Access Compliance Report

Public Rights-of-Way

Intersection ID: 23101	Main Street: LYNBRIDGE_DR	Cross Street: PROVIDENCE_RD	Location: NE
ADA ID: 7BE65DD249E8	Ramp Type: Perp	Initial Pass/Fail: Fail	Overall Compliance: No
		Severity Score: 12.5

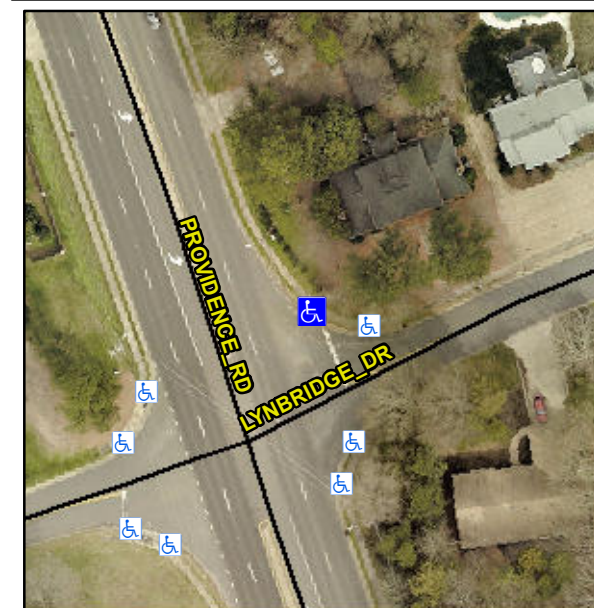
Not Found, R304.2.2

Compliance	Description	Data	Compliance	Description	Data
N/A	Ramp Length (in)	68.0	No	Ramp Slope (%)	8.8
Yes	Ramp Width (in)	49.0	Yes	Ramp XSlope (%)	0.4
N/A	Flare Type LT	N/A	N/A	Flare Type RT	N/A
N/A	Flare Slope LT (%)	N/A	N/A	Flare Slope RT (%)	N/A
N/A	Flare Traversable LT?	N/A	N/A	Flare Traversable RT?	N/A
N/A	Landing Length (in)	N/A	N/A	DWS Provided?	N/A
N/A	Landing Width (in)	N/A	N/A	DWS Contrast?	N/A
N/A	Landing Slope (%)	N/A	N/A	DWS Length (in)	N/A
N/A	Landing X Slope (%)	N/A	N/A	DWS Full Width?	N/A
N/A	Landing Curb? (Y/N)	N/A	N/A	DWS Offset (in)	N/A
N/A	Shared Landing?	N/A			
N/A	Gutter Ponding?	N/A	N/A	Gutter Slope (%)	N/A
N/A	Gutter Lip Ht (in)	N/A	N/A	Gutter X Slope (%)	N/A
N/A	Painted X Walk1?	No	N/A	Painted X Walk2?	N/A
	X Walk 1 Direction	To SW		X Walk 2 Direction	N/A
N/A	X Walk 1 Width (in)	N/A	N/A	X Walk 2 Width (in)	N/A
	X Walk 1 Slope (%)	1.2		X Walk 2 Slope (%)	N/A
	X Walk 1 X Slope (%)	1.4		X Walk 2 X Slope (%)	N/A

Remove & Replace Entire Ramp.
